MIT/IL PROGRAM CHANGE ROUTING SLIP

MIT/IL SOFTWARE ANOMALY REPORT

PG 1 OF 5
 MSC REPORT NO. L-18-10
 PROGRAM LUMINARY 1B
 PROGRAM REVISION 116

Fig. 3.4-16. Manual rate control logic for the P axis.

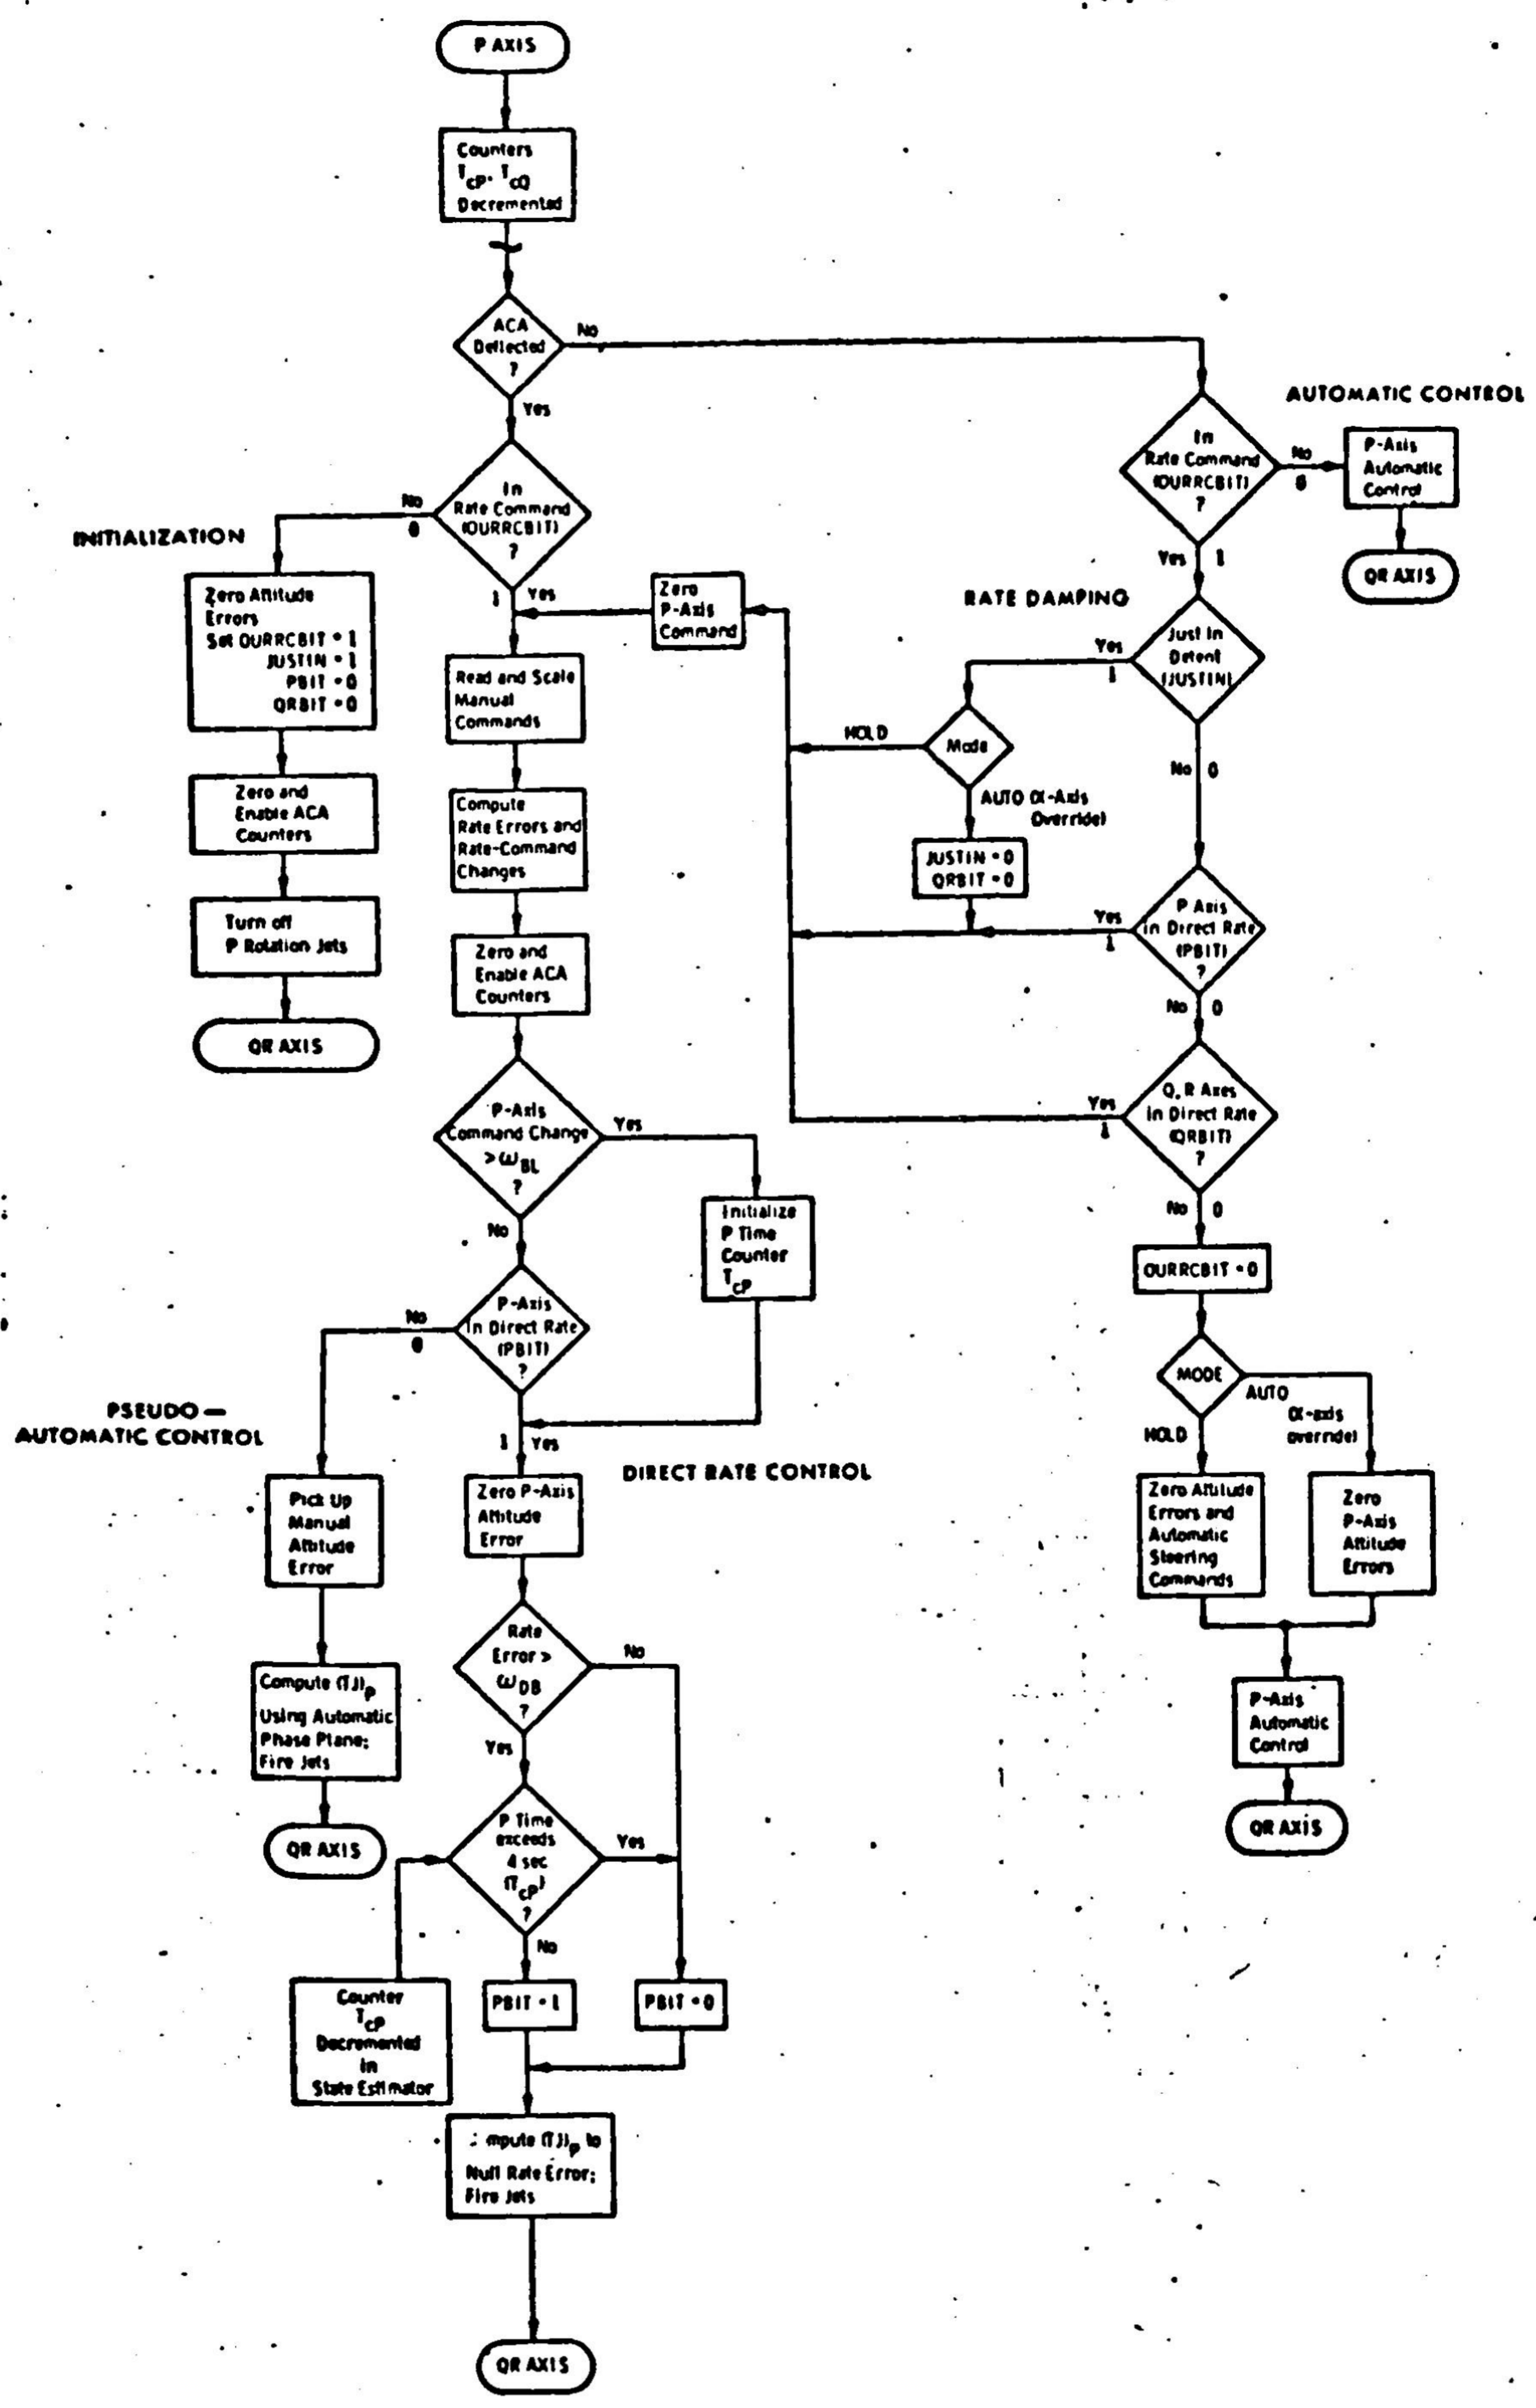
When the ACA is returned to the detent position after being recycled in and out of detent in the manual rate command mode, the DAP may enter the attitude hold mode immediately, rather than first damping the spacecraft rates as desired.

When the stick is returned to detent as detected in P axis (Fig. 3.4-16), OURRCFLG is tested and since it is 1, JUSTIN is tested. Since JUSTIN is also 1, the routine would continue on to Q, R -Axis (Fig. 3.4-17). Here the condition of the stick (as determined by a check of CH31 in P-Axis and buffered in CH31TEMP) is checked.

Since it is in detent OURRCFLG is checked and being found set, JUSTIN is reset. Assuming rate command changes and prime axes rate errors greater than the break out level and the rate deadbands respectively, Direct Rate Control will be established by setting RCSFLAGS B11, QRBIT. On the next P-Axis pass with the stick still in detent OURRCFLG is still set but though JUSTIN is reset, transfer is made to Q, R - Axes without resetting OURRCFLG (see Fig. 3.4-16) because QRBIT is set.

However, if the stick is returned to detent after Pseudo - Auto has been established (QRBIT reset) then after the test of OURRCFLG (refer to Fig. 3.4-16) the tests on JUSTIN and QRBIT will find them both reset so OURRCFLG will be reset. Now in Q, R - axes, when OURRCFLG is tested and found to be reset, the program flow will be transferred to Automatic Control.

Set JUSTIN to 1 each time the ACA is found out of detent in Fig. 3.4-16.

No action required for LUMINARY 1B.
Fix coding for LUMINARY 1C.
